CONTEMPLATED CHANGE ORDER NO. 1	
PROJECT: San Pareil UV Disinfection Upgrades	PROJECT NO.: 1683
OWNER: Regional District of Nanaimo	CCO No.: 1 REV2
TO: Garth O'Neill	DATE: May 2, 2018
CONTRACTOR: Ridgeline Mechanical Ltd.	TOTAL NO. OF PAGES: 2
SUBJECT: Contemplated Change Order Request	
ATTACHED: RB Engineering Ltd Drawing SKE-1 (dated: Mar 9, 2018) & SKE-2 REV 1 (dated April 11, 2018) & RB Engineering Ltd. San Pareil Water Treatment Upgrades – Scope Change (dated: May 2, 2018)

San Pareil Water Treatment Upgrades – Scope Change

SKE-1

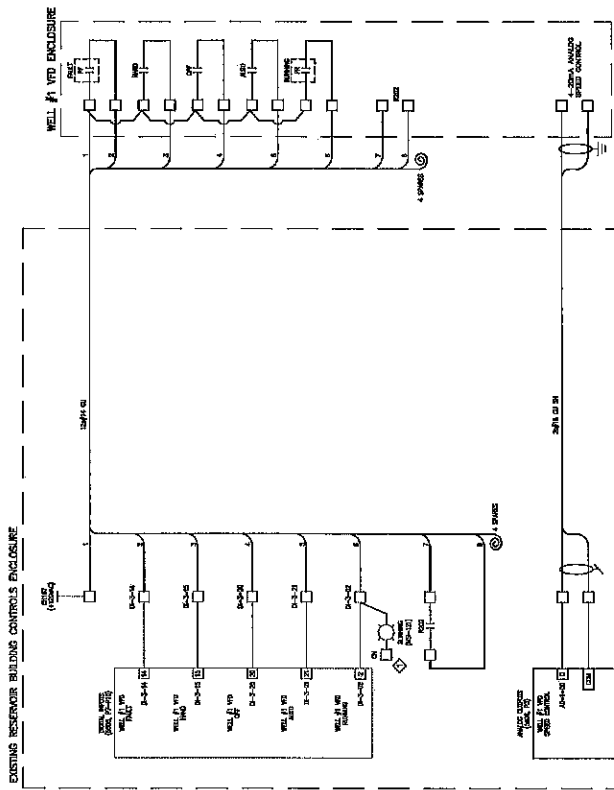
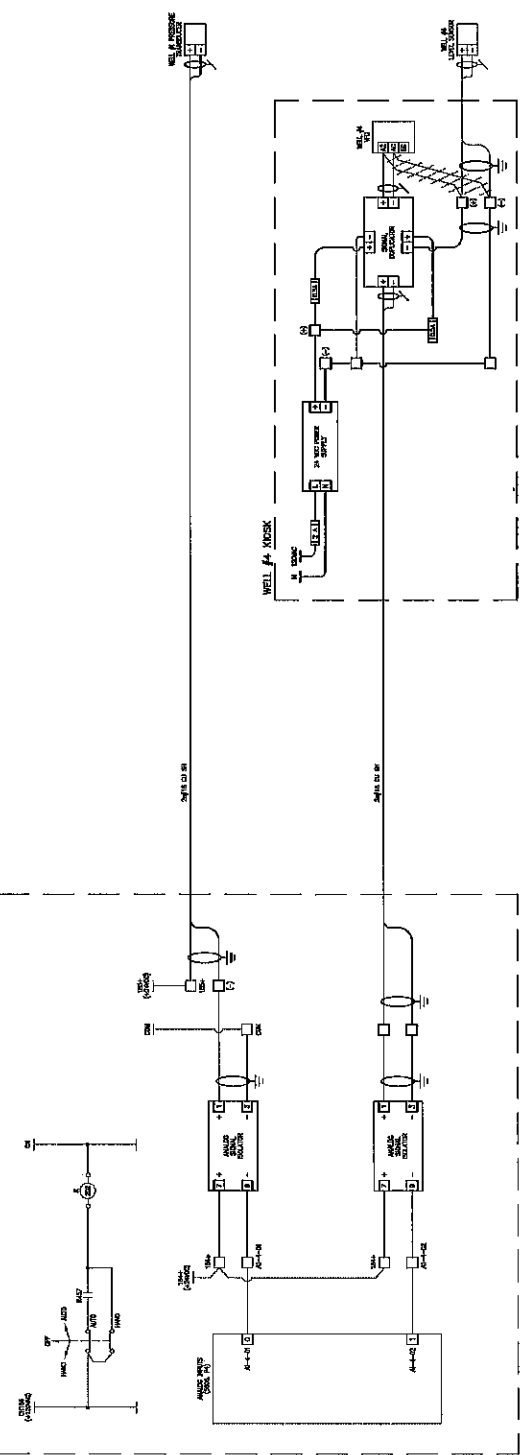
1. Add Input/Output Card to Existing SCADAPack
 - a. Add a 5305 analog output card to the existing SCADAPack Controller to enable expansion of sensor outputs.
 - b. Update SCADAPack program to recognise addition of the card as required.

- c. Add terminal blocks and wiring in the control cabinet to extend all new SCADAPack I/O points. All field terminations shall be to these intermediary terminal blocks.

2. Install a NEMA 3R kiosk complete with VFD for well pump at well #1 as follows:
 - a. Kiosk to be fabricated from marine grade aluminum or stainless steel and include insulation, heat, ventilation, lighting and affiliated controls as required for the proposed equipment.

- b. Install 300mm deep concrete base and all conduit for power and control as required. Concrete base to be no closer than 1m from well to allow suitable clearance for maintenance. Contractor to confirm kiosk location with RDN.

- c. Intercept and extend existing well pump power feed such that the VFD is fed by the existing 208 V, 3 phase feeder and the pump power conductor connects to the VFD.

- d. VFD to be enclosed in separate enclosure within the kiosk, be manufactured by Franklin Electric or Rockwell Automation, and include the following:

- ii. Use existing starter enable for VFD enable input
 - iii. 4-20mA speed control input
 - iv. Form C contact for the following outputs:
 1. VFD fault
 2. Local VFD switch in HAND

3. Local VFD switch in OFF
 4. Local VFD switch in AUTO
 5. Pump running
3. Undertake manufacturer testing and commissioning of the VFD including configuration of pump ramp up/down, soft start, soft stop, speed control, and operation in Hand, Off, and Auto modes. Provide commissioning report to the Engineer.

4. Run 12C #14 control cable from VFD through conduit system back to existing San Pareil SCADAPack controller in the reservoir building control panel for discreet I/O.

5. Run 2C #18 shielded current loop cable from VFD through conduit system back to existing San Pareil SCADAPack controller in the reservoir building control panel for pump speed control.
6. Program SCADAPack to:
 - a. Store and control incoming VFD digital I/O.
 - b. Operate the well pump VFD at 100% when the reservoir control cabinet HOA switch is in Hand.
 - c. Disable the VFD when the reservoir control cabinet HOA switch is in Off.
 - d. Operate the well pump VFD at an operator adjustable speed control setpoint when the reservoir control cabinet HOA switch is in Auto (Civil Engineer to provide default set point).
7. Program the HMI to:
 - a. Display the current pump operating frequency.
 - b. Display the status of the remote and local HOA switches.
 - c. Display a user configurable operating set point of the water level complete with configuration interface.
